# Specification for Drilling and Production Hoisting Equipment

API SPECIFICATION 8A THIRTEENTH EDITION, DECEMBER 1997

ADDENDUM 1, MAY 2001

## Addendum 1 to Specification for Drilling and Production **Hoisting Equiment**

Figure 5—Elevator Link and Link Ear Contact Surfice Radii (See Tables 3A and 3B)

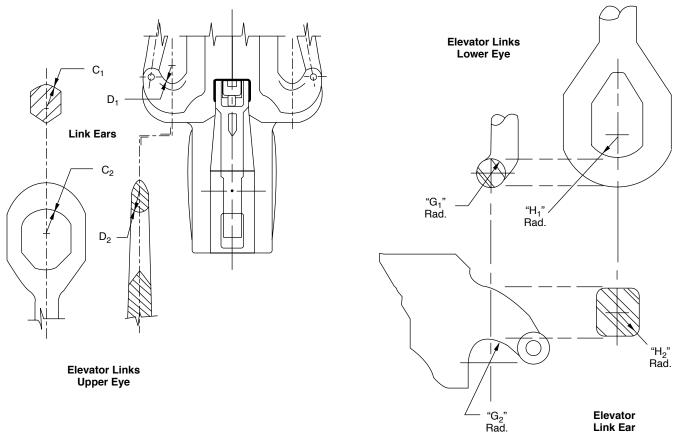
#### Page 13, Figure 5:

Replace entire figure.
